HISTORIC PRESERVATION COMMISSION REPORT

Case Name: Lentz Townhouse Front Yard Landscape Renovation

Case Number: 36-HP-2019

Location: 7714 East Northland Drive

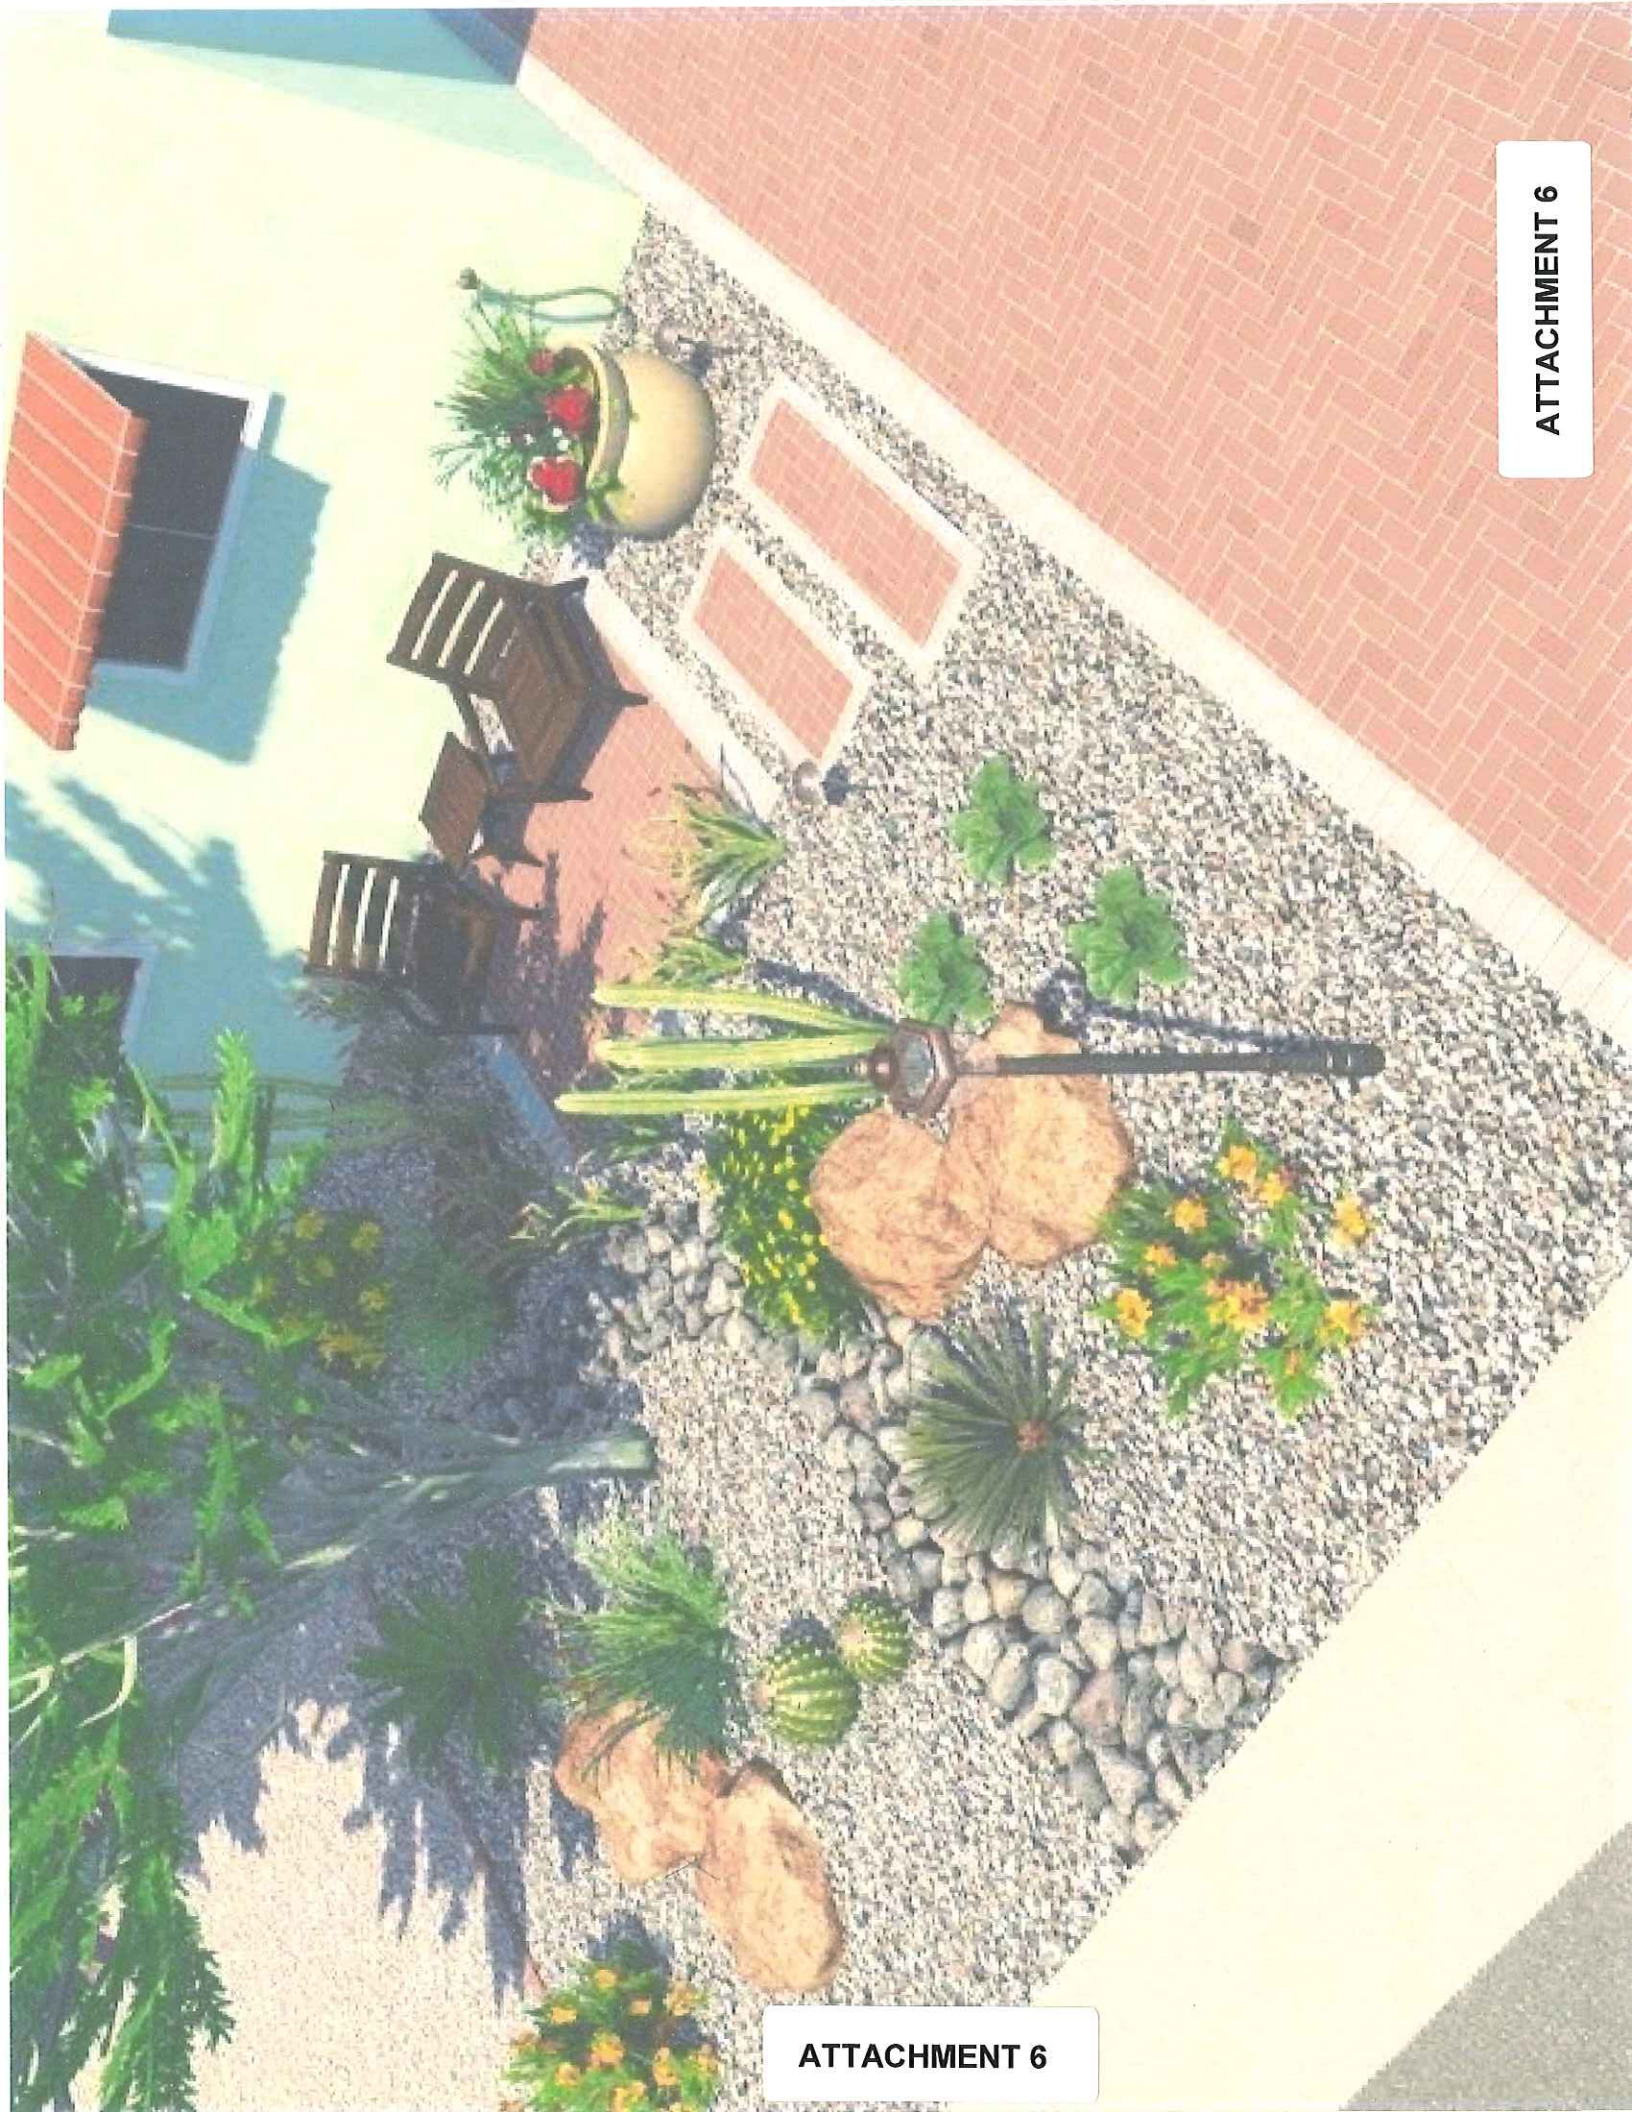
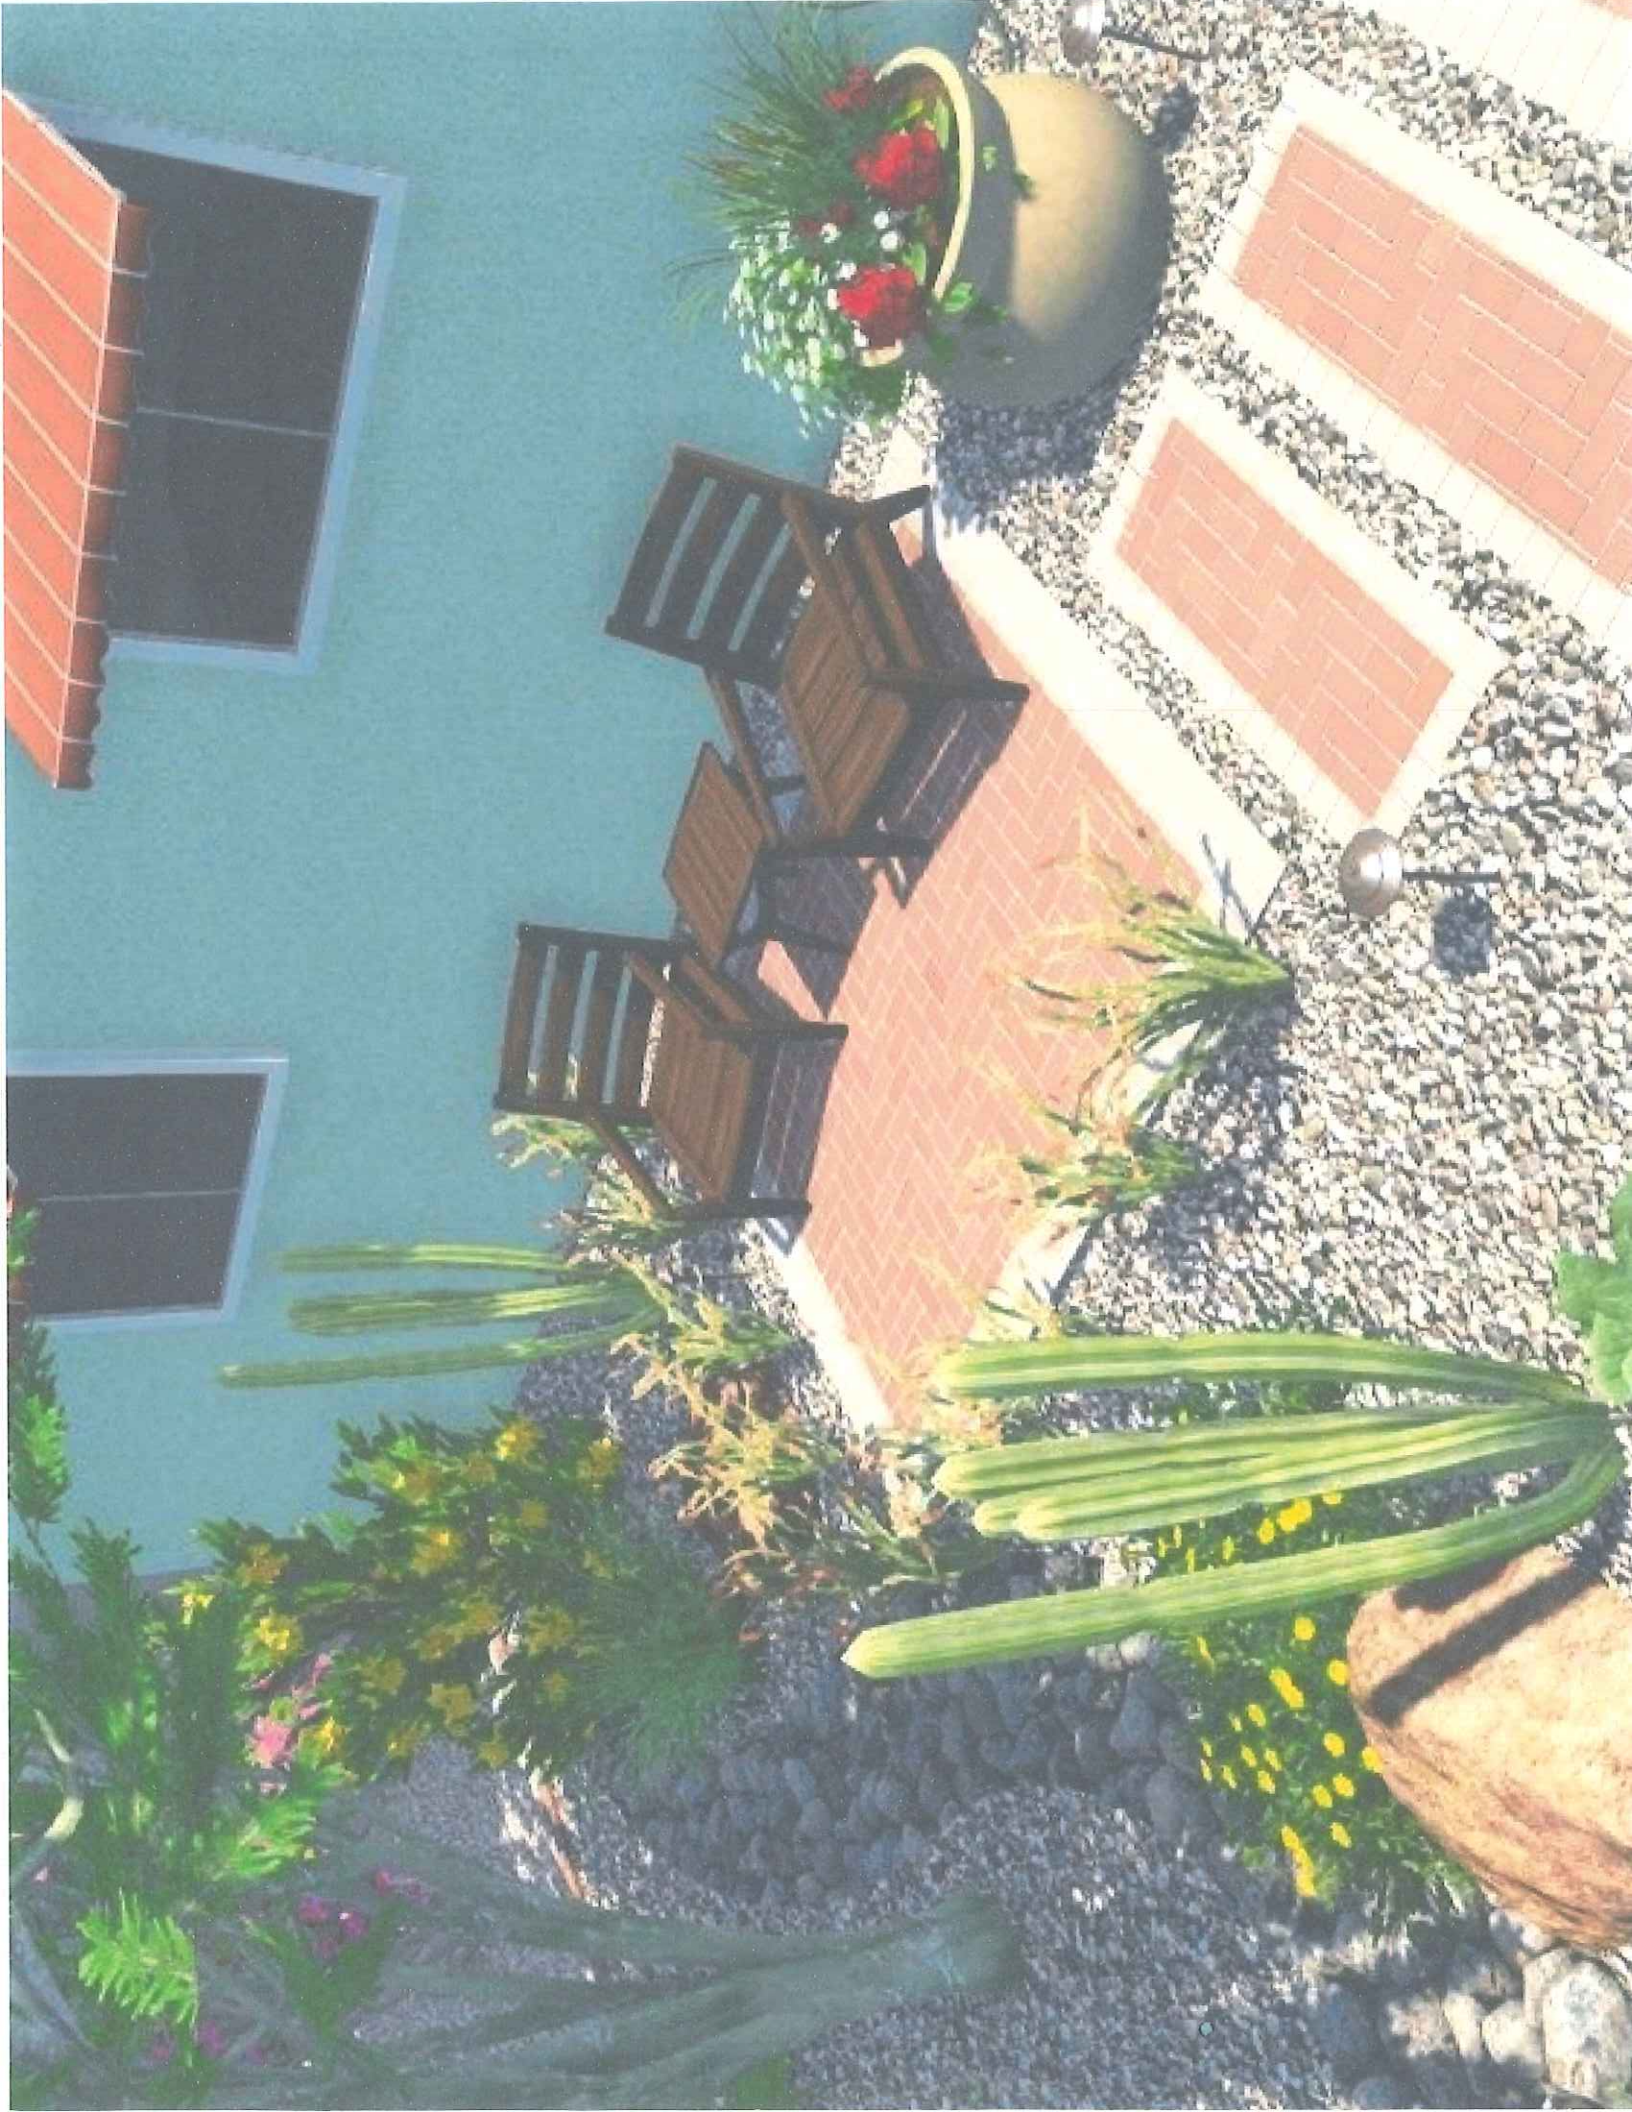
The property originally had turf and a large palm tree which was removed. The applicant is proposing to plant a 24" box Palo Verde or Palo Brea tree in the front yard and drought tolerant groundcover and Golden Barrel cactus plants.

The applicant is proposing to use drought tolerant plants.

The applicant is not proposing to enclose the patio area.

The applicant is proposing one tree and the rest of the landscaping proposed is low scale groundcover providing visibility to the façade and windows of the townhouse. The property owner has received approval from their HOA for the brick patio and landscaping.

Staff recommends that the Historic Preservation Commission approve Lentz Townhouse Front Yard Landscaping Renovation finding that the provisions of General Plan Preservation and Environmental Planning and the Interim Villa Monterey Units 1-7 Historic Preservation Guidelines have been met.
